CITY OF GLENDALE, CA

DESIGN REVIEW STAFF REPORT – MULTI-FAMILY / MIXED USE

| September 8, 2022 <i>Decision Date</i> | 3301 Honolulu Avenue <i>Address</i> |
| PDR 2205172 <i>Case Number</i> | Sean Choe <i>Applicant</i> |

Sheet No
A-2
 of

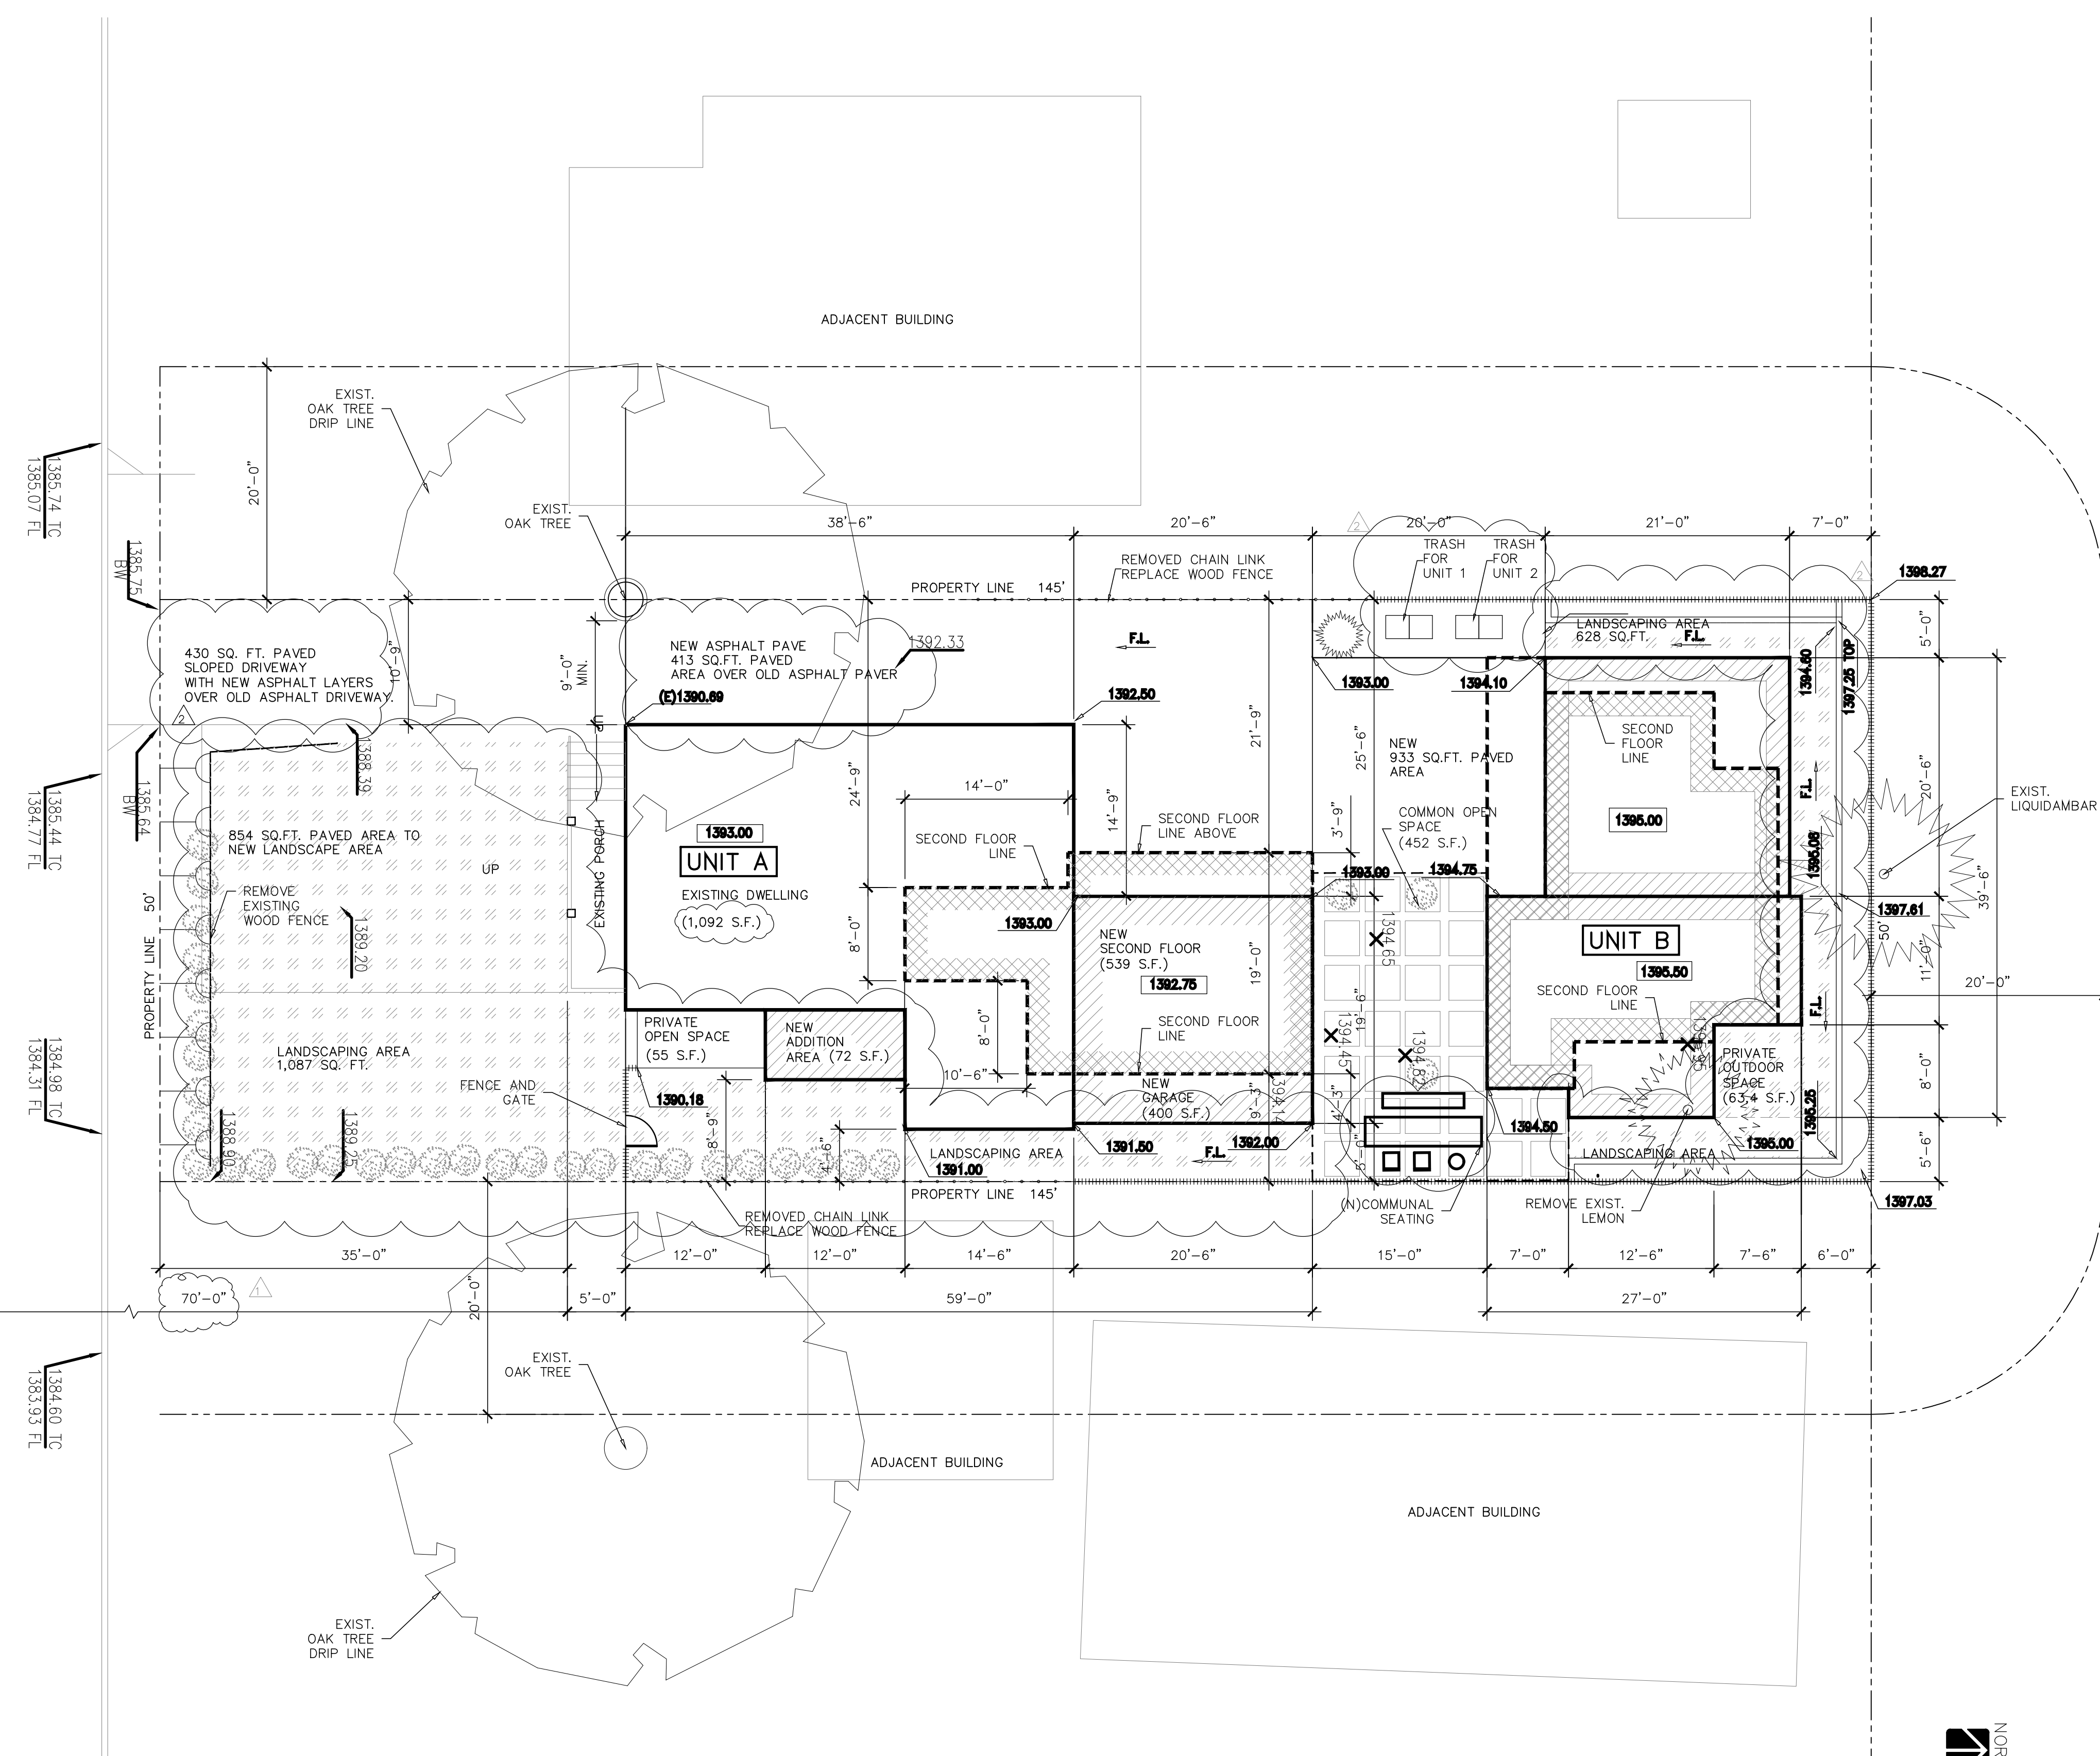
The plans indicate that the asphalt along the existing driveway will be replaced with new asphalt. The City’s Comprehensive Design Guidelines indicate that decorative and/ or permeable paving materials should be used. Additionally, the comments from the Urban Forestry Division (Attachment #5) include a condition that the driveway be redesigned to provide optimal conditions and protection for the root zone of the existing Oak tree in this area. Staff is recommending a condition of approval that the driveway paving material be revised to be decorative, with consideration given to a permeable paving material, and to the satisfaction of the City’s Urban Forestry Division.

The City’s Design Guidelines require fences and walls to be consistent with the architectural style and that the placement be behind the street-face of the adjacent buildings. The site plan identifies a new fence and gate located along the easterly portion of the site in line with the front façade of the existing house and new deck, and no information is provided regarding the design. Staff is recommending a condition of approval that the fence and gate be setback to be in line with the addition along the easterly façade, not the new deck and building wall, and that the design of the gate be submitted for staff review and approval.

- The site plan identifies a new fence and gate located along the easterly portion of the site that is in line with the front façade of the existing house and new deck, and no information is provided regarding the design. A staff recommended condition of approval will require the fence and gate be setback to be in line with the addition along the easterly façade, not the new deck and building wall, and that the design of the gate be submitted for staff review and approval.

1. That the applicant shall comply with all of the recommendations identified in the Urban Forestry Department Comments dated August 11, 2022.
2. That the landscape plans and site plant be revised to be consistent with one another and that the plant palette be revised so all new landscaping is drought tolerant and feature California-native plants with a low or very low water use designation in keeping with Phase III of the City's Water Conservation Ordinance.
3. That the driveway paving material be revised to be decorative, with consideration given to a permeable paving material, and to the satisfaction of the City's Urban Forestry Division.
4. That the fence and gate be relocated to be in line with the addition along the easterly façade, and that the design of the gate be submitted for staff review and approval.

LANDSCAPE PLAN

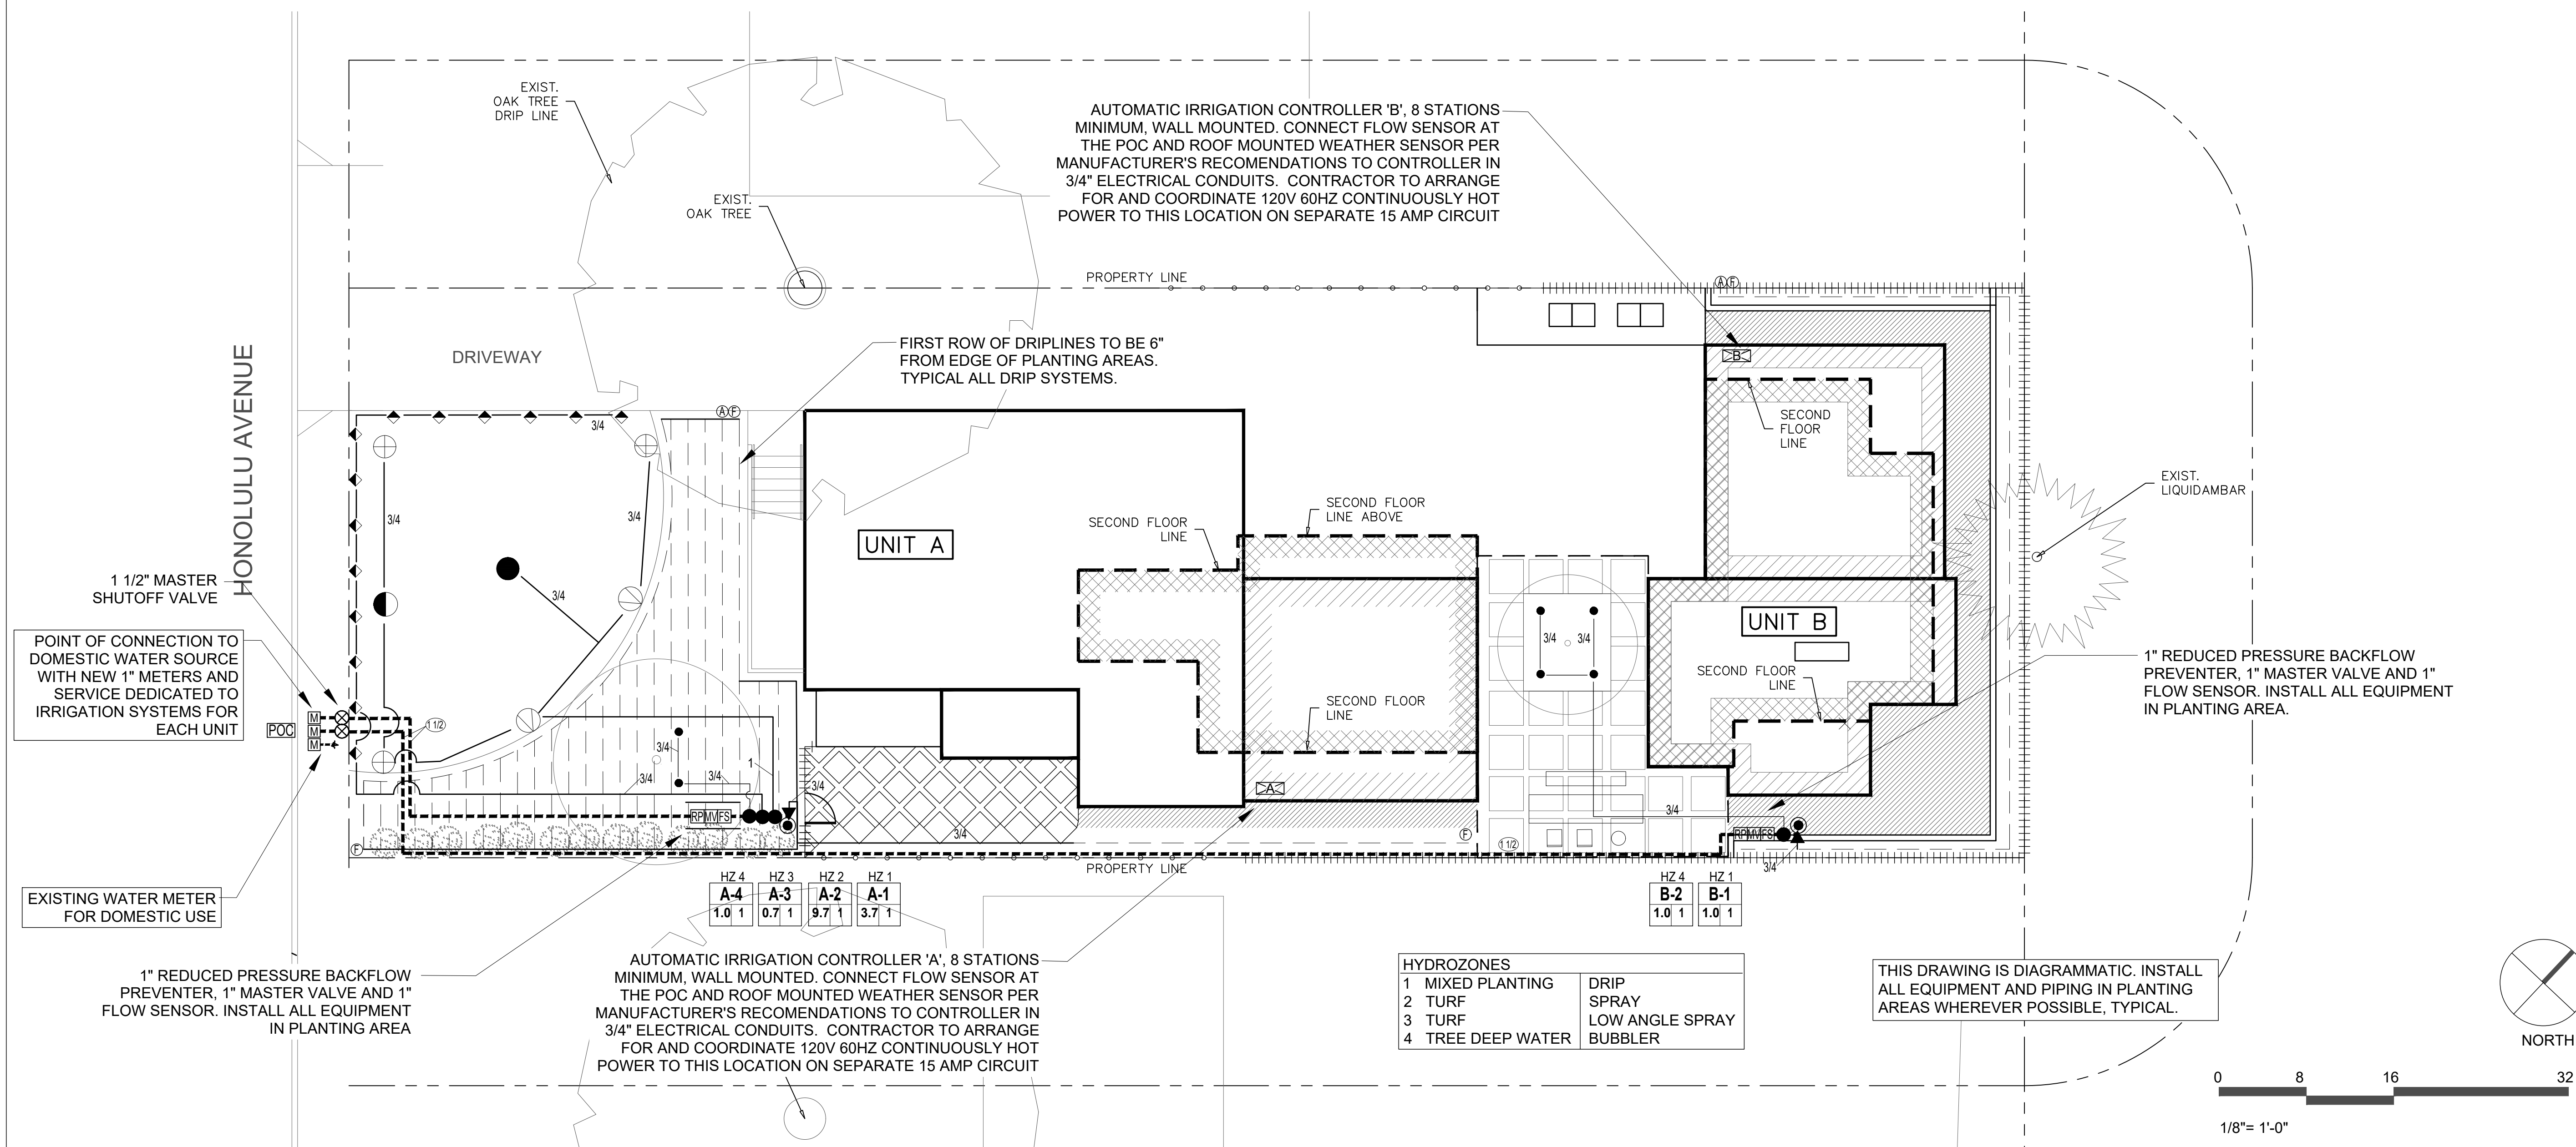
Overall, the landscape design complements the project, with drought tolerant landscaping proposed throughout. However, the City recently entered Phase III of the City’s Water Conservation Ordinance which requires landscaping to be drought tolerant with California-native plants with a low or very low water use designation. Additionally, the site plan and landscape plans have some discrepancies related to the location of hardscape around the new unit. As such, staff is recommending a condition of approval that the plant palette be revised to feature plantings that satisfy the low or very low

water usage requirement, and that the architectural and landscape drawings be revised to be consistent with one another.
